Quotiq sample subcontractor package

Marked-up subcontractor sheet - Partitions - Page 1

FIRST FLOOR PLAN
1/4" = 1'-0" 1:48

ELLIS ISLAND, CONTAGIOUS DISEASE HOSPITAL OFFICE BUILDING
STATUE OF LIBERTY NATIONAL MONUMENT NEW YORK HARBOR NEW YORK NEW YORK COUNTY NEW YORK

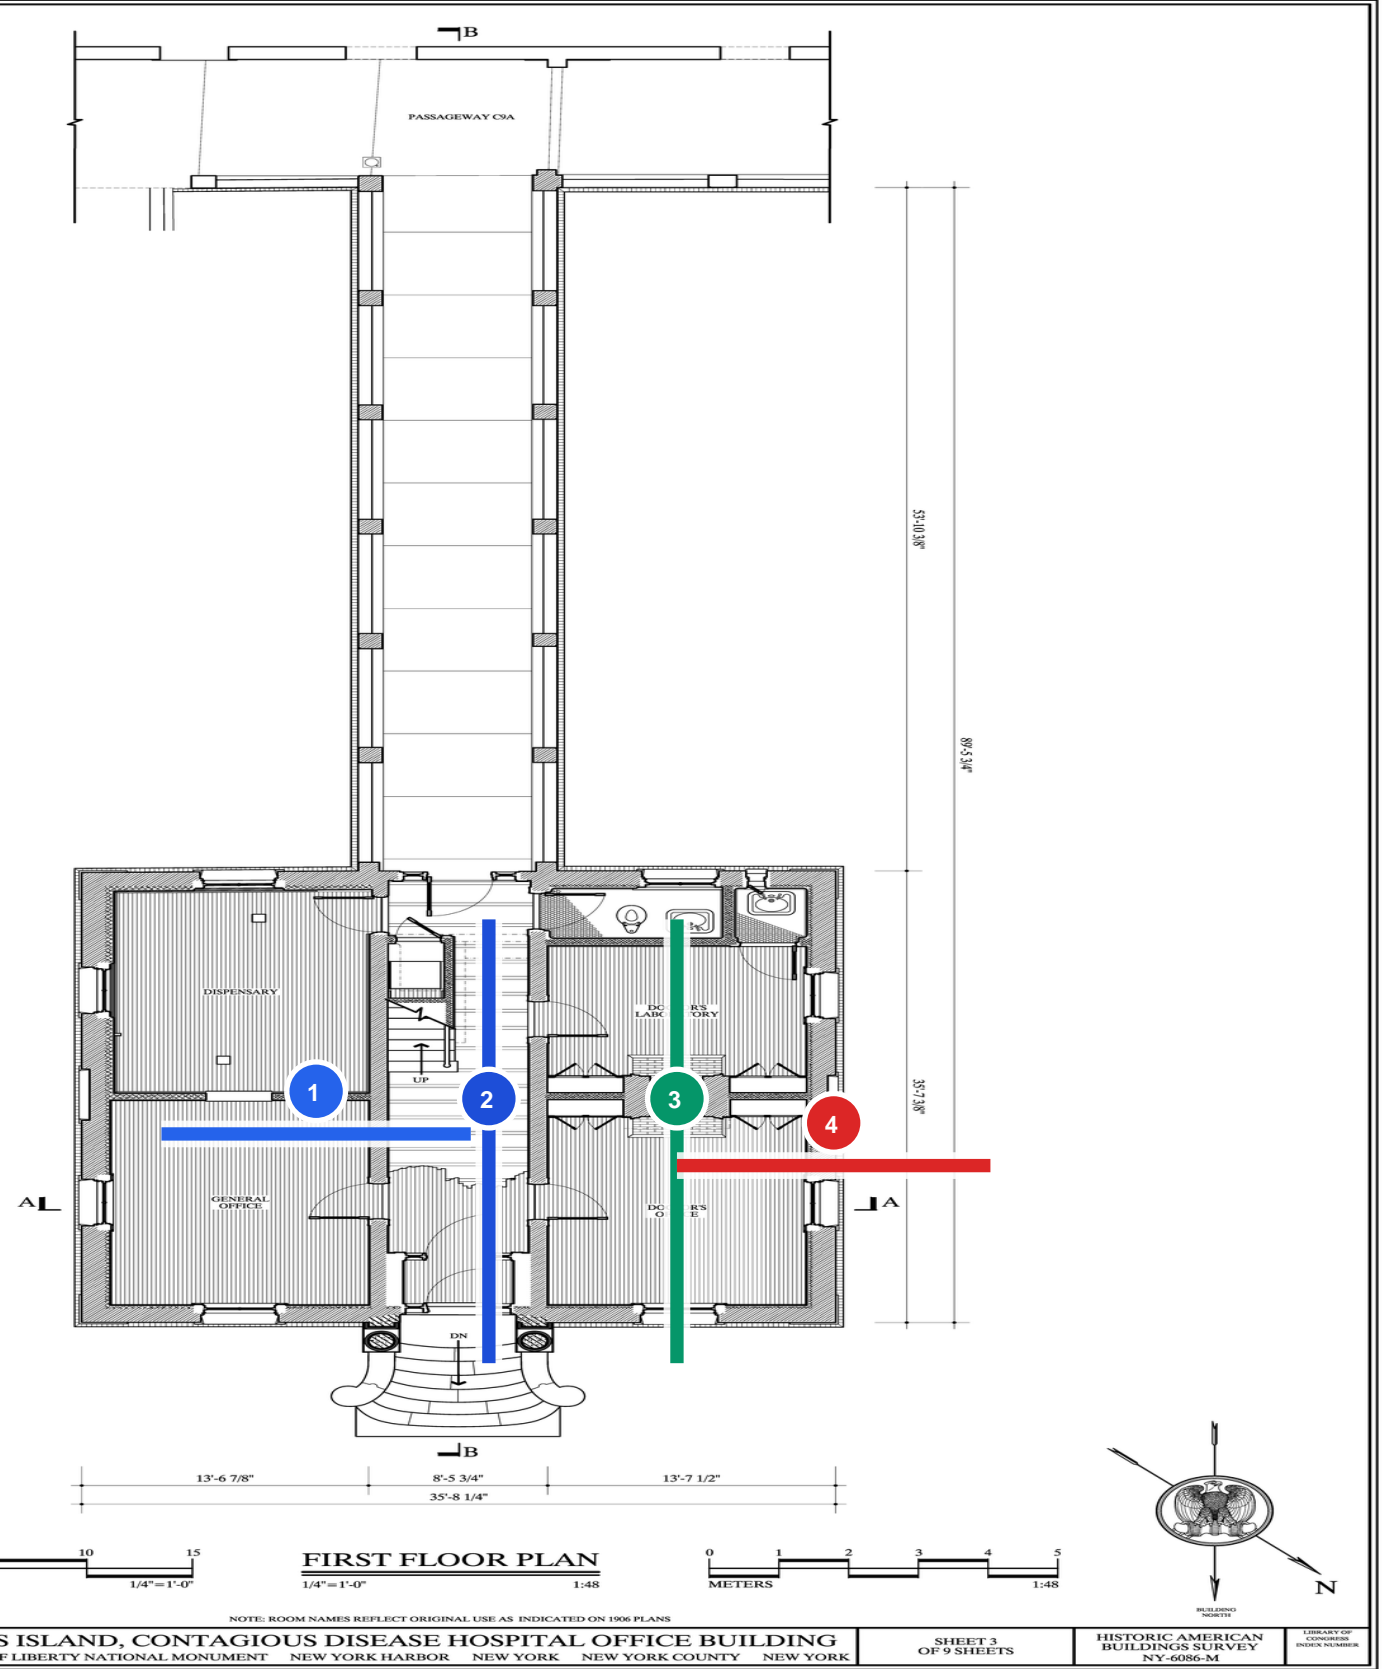
- 1** 100mm 40kg drywall
10.9 m2
- 2** 100mm 80kg drywall
28.2 m2
- 3** Single-glazed, framed
28.2 m2
- 4** Fire-rated partition
11.0 m2
